PREVOST

SAFETY RECALL

SR22-09

DATE :	Month 2022	SECTION :	18 BODY
SUBJECT:	Passenger Seats – Center Belt Buckle Replacement

Figure 2: Remove buckle

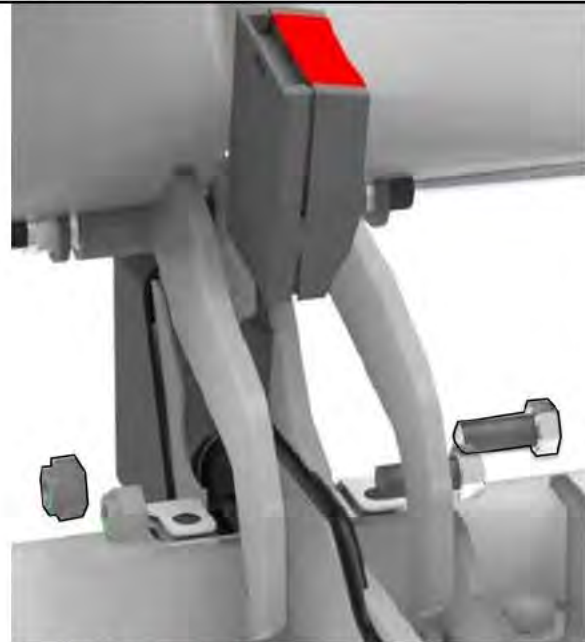
2. Recline backrest.
3. Remove *center* belt buckle by removing 7/16" screw.
4. On rear cross seat, remove buckles in all seat positions.
5. Discard buckle and hardware.

Figure 3: New buckle in top hole.

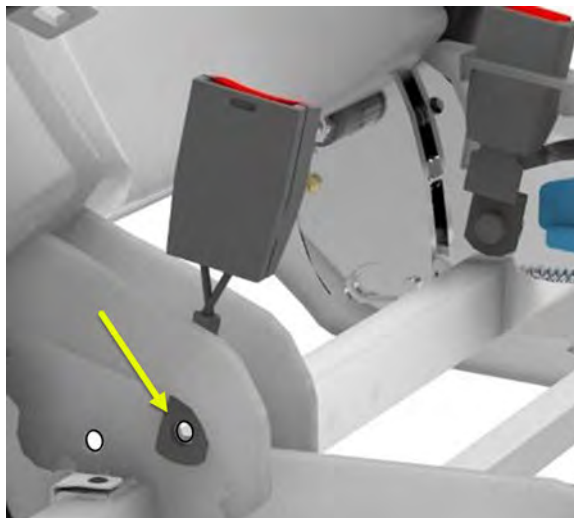
6. Install new buckle with new hardware in the **top-hole** position.
7. Tighten to **28-35 lb-pi**
8. Apply torque seal mark.

Figure 5: Center buckle access

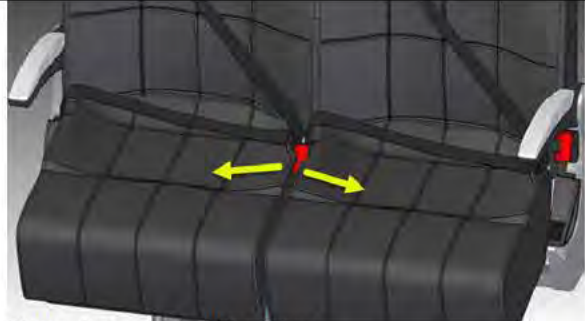
10. Access buckle mounting point by widening the cushion gap.

Figure 6: buckle removal

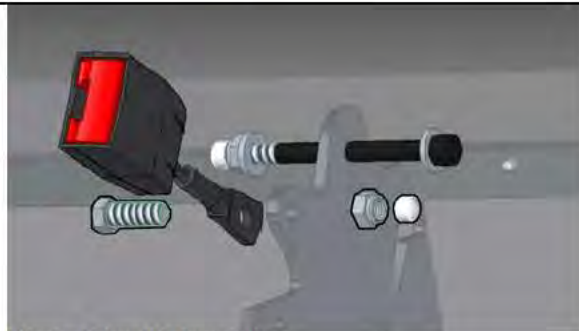
11. Remove buckle and hardware. Discard.

Figure 7: Buckle installation

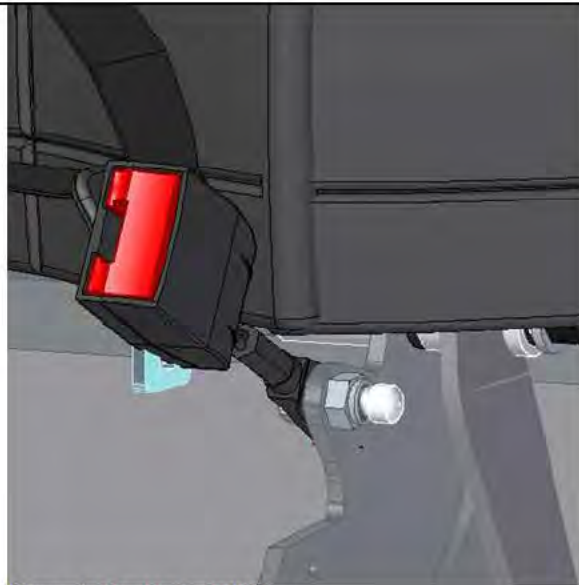
12. Install new buckle with new hardware.
13. Tighten to **28-35 lbf-pi**
14. Apply torque seal mark.
